UNITED STATES PATENT AND TRADEMARK OFFICE

APPLICATION NO.	FILING DATE	FIRST NAMED INVENTOR	ATTORNEY DOCKET NO.	CONFIRMATION NO.
10/780,320	02/17/2004	Jack E. Caveney	LCB432	1108

Office Action Summary	Application No.		Applicant(s)	
	10/780,320		CAVENEY ET AL.	
	Examiner		Art Unit	
	Philip Gabler		3637

DETAILED ACTION

Thiede et al. '498 Figures 2-4

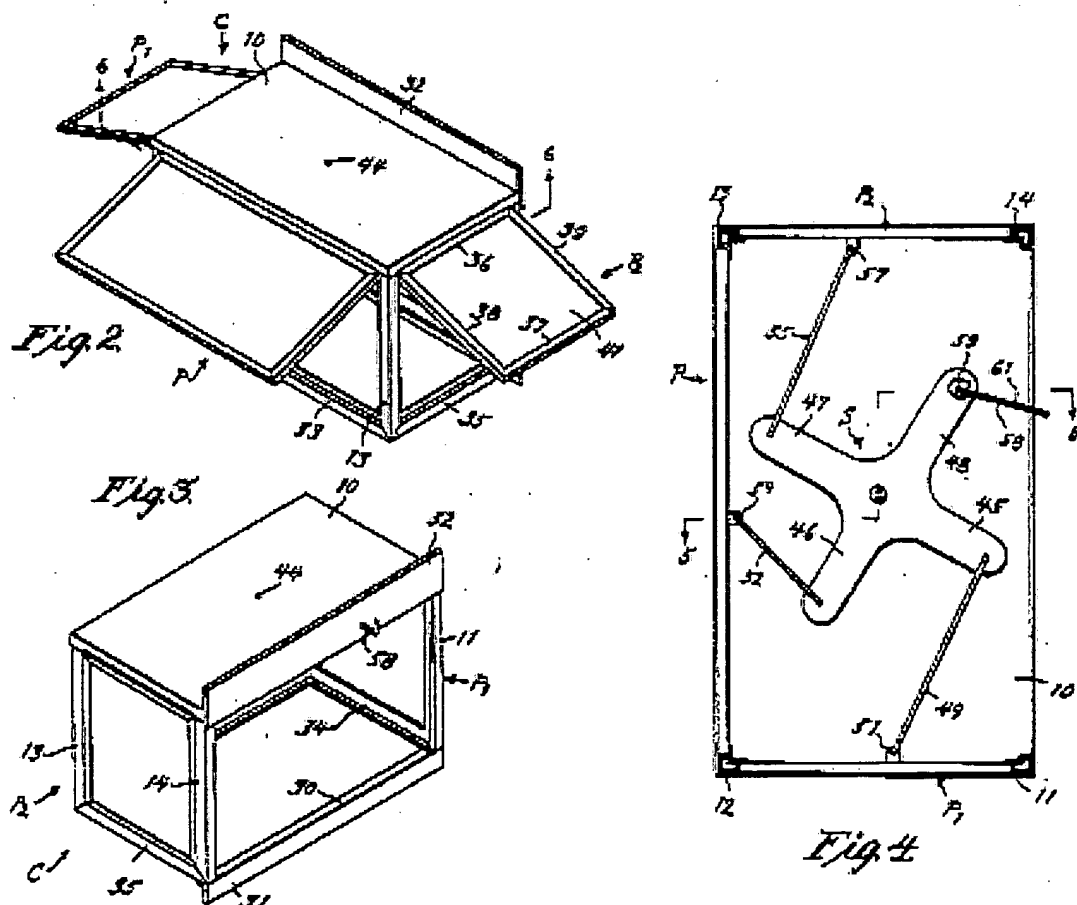
3. Claims 1 and 3 are rejected under 35 U.S.C. 102(b) as being anticipated by Thiede et al. (US Patent Number 3006498). Thiede (Figures 2-4) discloses a wall mountable cabinet comprising: a rear section (10-14, 31-35, etc.) having a top side (10), a bottom side (members 30, 33, 34, etc.), and a first side (formed by 11, 12, etc.) between the top side and the bottom side, the rear section including a cutout area (space defined by members 12, 13, 33, etc.) extending from the first side along a portion of the top side, wherein the cutout area is capable of allowing access for cables

to enter the cabinet; and a front section (P) hingedly connected to the rear section at a pivot point (front edge of 10) adjacent the cutout area, wherein the cutout area is capable of allowing cables to rotate about the pivot point when the cabinet is moved from a closed position to an open position (the opening and closing of front section, P, for instance).

4. Regarding claim 3, Thiede further discloses two side access panels (P1 and P2) hingedly connected to the front section (through mechanism S and links 49, 52, and 55).

Exhibit 1: Hansson '362 Figures 1, 2, and 4

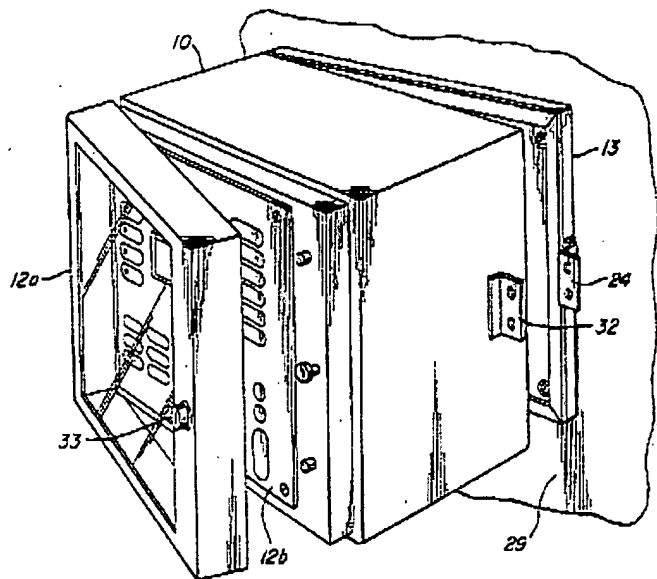
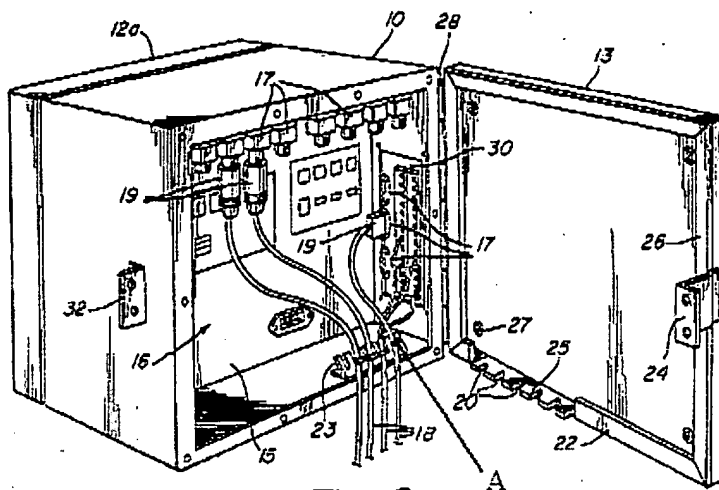
5. Claims 1, 4, 6, 7, 9, 11, 14, 17, 19, and 23 are rejected under 35 U.S.C. 102(b) as being anticipated by Hansson (US Patent Number 5568362). [Note that for the 35 USC 102(b) rejections in view of Hansson, Hansson's device is viewed in an inverted position as shown in Exhibit 2.] Hansson (Figures 1, 2, and 4) discloses a wall mountable cabinet comprising: a rear section (13) having a top side (at member 22), a bottom side (opposite member 22), and a first side (hinge side of 13) between the top side and the bottom side, the rear section including a cutout area (20) extending from the first side along a portion of the top side, wherein the cutout area is capable of allowing access for cables to enter the cabinet; and a front section (10) hingedly connected to the rear section at a pivot point (28) adjacent the cutout area, wherein the cutout area is capable of allowing cables to rotate about the pivot point when the cabinet is moved from a closed position to an open position (the movement of the front section about pivot point 28, for instance).

6. Regarding claim 4, Hansson further discloses a front door (12a) hingedly connected to the front section (see Figure 1), wherein the front door includes a transparent window (see column 1 lines 64-65).

7. Regarding claim 6, Hansson further discloses a slack cable manager (viewed as A in Exhibit 1) secured to a rail (23) mounted therein.
8. Regarding claim 7, Hansson further discloses a patch panel (30) secured to a rail (15) mounted therein.

9. Regarding claim 9, Hansson further discloses active equipment (17, 19) secured to a rail (15) mounted therein (via panel 30).

10. Regarding claim 11, Hansson discloses a wall mountable cabinet comprising: a rear section (13) having a top side (at member 22), a bottom side (opposite member 22), and a first side (hinge side of 13) between the top side and the bottom side, the rear section including a cutout area (20) extending from the first side along a portion of the top side; and a front section (10) hingedly connected to the rear section (through hinge 28), the front section having a cable management ring (A, which points to a cable tie secured to tie bracket 23, the cable tie being viewed as a cable management ring) secured thereon, wherein when the cabinet is in a closed position, the cable management ring is vertically aligned with the cutout area (as is clear in Figure 2, where a vertical cable, 18, passes through the cable management ring and is aligned to enter the cutout area upon closure of the cabinet).

Ehrenfels '129 Figures 1, 2, and 5

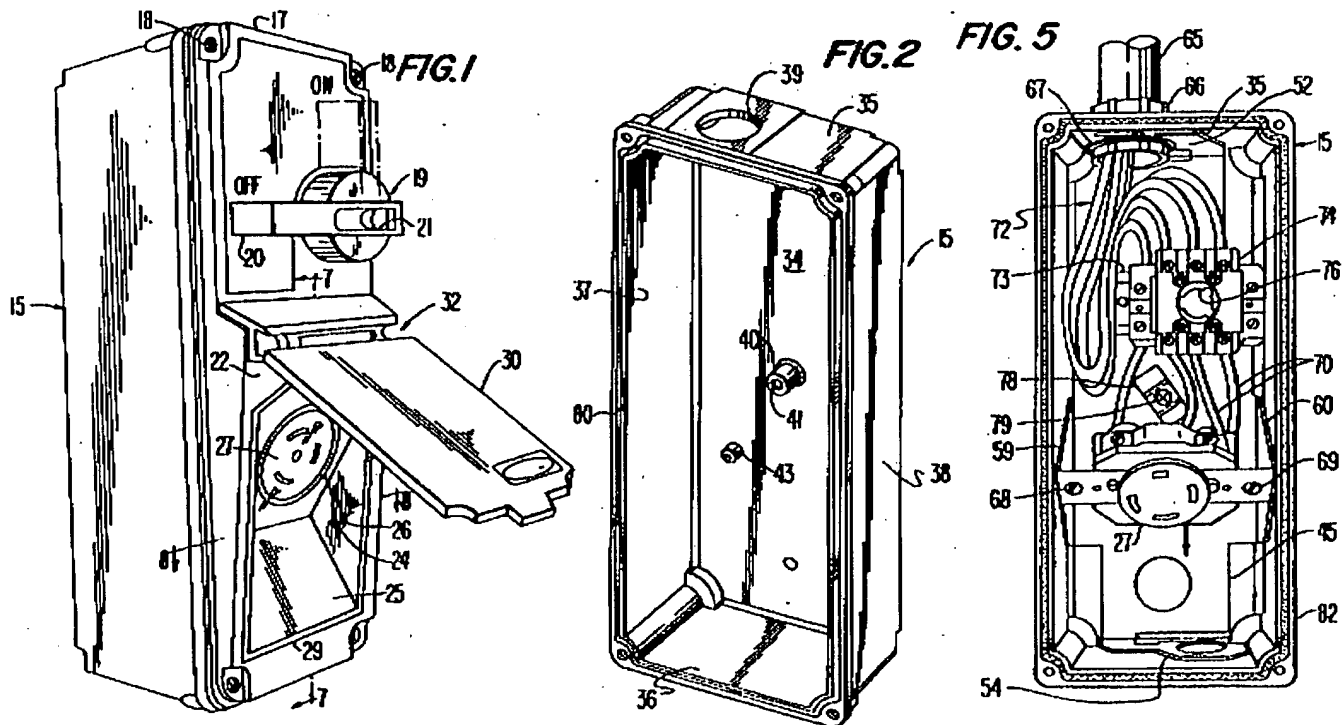
26. Claims 2 and 12 are rejected under 35 U.S.C. 103(a) as being unpatentable over Hansson in view of Ehrenfels (US Patent Number 5239129). Hansson discloses a wall mountable cabinet as recited in claims 1 and 11 as described above but does not disclose a duct positioned adjacent the cutout area. Ehrenfels discloses a wall mountable cabinet with a duct (65) adjacent to a cutout area (39). Accordingly, it would have been obvious to one of ordinary skill in the art at the time the invention was made to modify Hansson's cabinet to include a duct positioned adjacent to the cutout area as taught by Ehrenfels because this arrangement would protect cables routed through the cutout area.

Nelson et al. '966 Figure 17

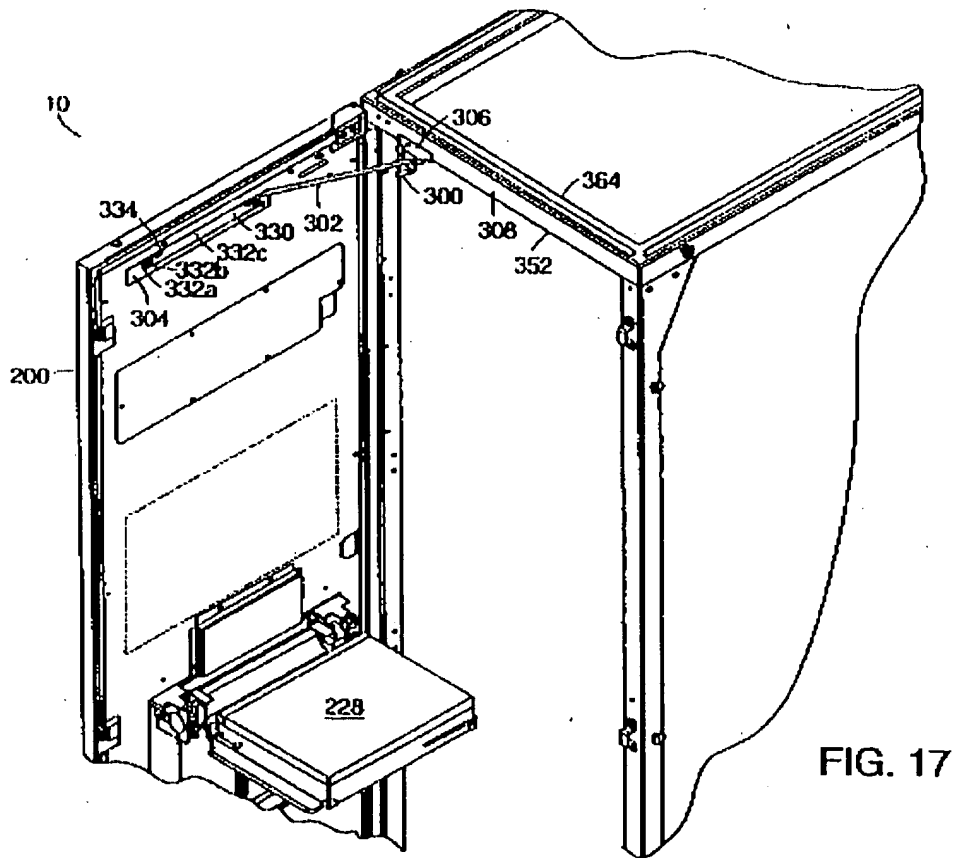
27. Claims 5 and 15 are rejected under 35 U.S.C. 103(a) as being unpatentable over Hansson in view of Nelson et al. (US Patent Number 6061966). Hansson discloses a wall mountable cabinet as recited in claims 1 and 11 as described above but does not disclose a rod which maintains the front section in an open position. Nelson (Figure 17) discloses a cabinet comprising a rod (302) which maintains the front section (200) in an open position about 90 degrees from the rear section (308). Accordingly, it would have been obvious to one of ordinary skill in the art at the time the invention was made to modify Hansson's cabinet to include a rod to maintain the front section in an open

position as taught by Nelson because this arrangement would facilitate access to Hansson's cabinet by providing a prop for the front section.

English et al. '233 Figure 1

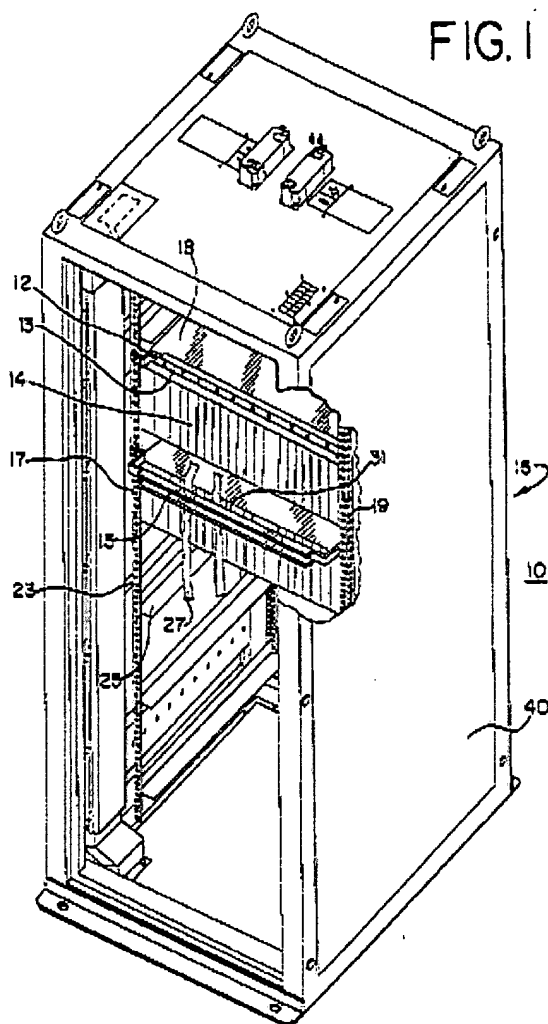
28. Claims 8, 10, 16, 18, and 22 are rejected under 35 U.S.C. 103(a) as being unpatentable over Hansson in view of English et al. (US Patent Number 6067233). Hansson discloses a wall mountable cabinet as recited in claims 1 and 11 as described above but does not disclose a horizontal cable manager secured to a rail. English (Figure 1) discloses a bar (12) mounted to a rail (17) intended for both cable management use and mounting of electronic modules (see column 3 lines 59-62) and

that is capable of supporting a slack cable manager, horizontal cable manager, patch panel or active equipment as is known in the art. Accordingly, it would have been obvious to one of ordinary skill in the art to modify Hansson's cabinet to include a cable manager or electronic component mount secured to a rail system as taught by English because this arrangement would provide more versatility to Hansson's cabinet while maintaining organization.

29. Regarding claims 10 and 22, Hansson discloses a wall mountable cabinet as recited in claims 4 and 14 as described above but does not disclose an adjustable rail. English discloses a rail (12) that can be adjusted (via holes 23) to various positions within a cabinet (10). Accordingly, it would have been obvious to one of ordinary skill in the art at the time the invention was made to modify Hansson's cabinet to include an adjustable rail as taught by English because this would allow greater flexibility as to what could be mounted in his cabinet.

Erickson '319 Figure 1

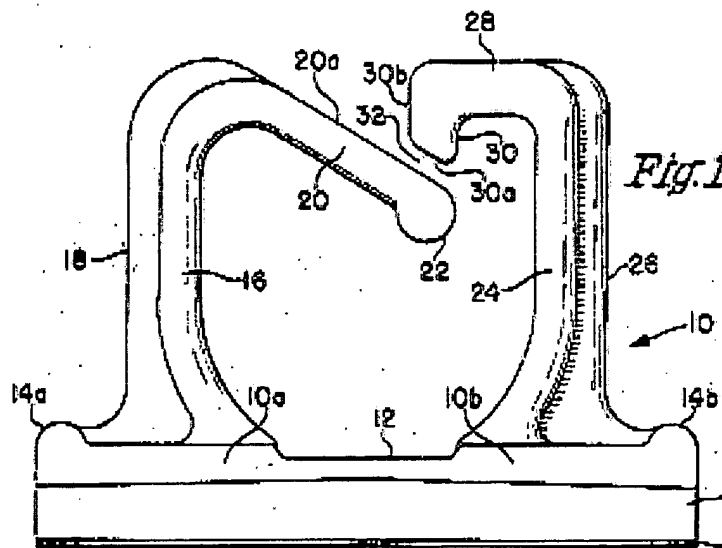
31. Claims 21 and 24 are rejected under 35 U.S.C. 103(a) as being unpatentable over Hansson in view of Erickson (US Patent Number 3659319). Hanson discloses a wall mountable cabinet as recited in claim 11 as described above but does not disclose a cable management ring with substantially L-shaped arms. Erickson (Figure 1) discloses a wire management clip with first (16 and 20) and second (24 and 28) substantially L-shaped arms having distal portions (20 and 28) oriented substantially 90 degrees from substantially linear portions (16 and 24), wherein the arms are formed of a material and construction capable of providing rotation (i.e. plastic; see column 2 lines 17-18) about the axis of their linear portions. Accordingly, it would have been obvious to one of ordinary skill in the art at the time the invention was made to modify Hansson's cable management ring to include substantially L-shaped arms as taught by Erickson because this arrangement would make securing and removing cables from the ring more efficient.
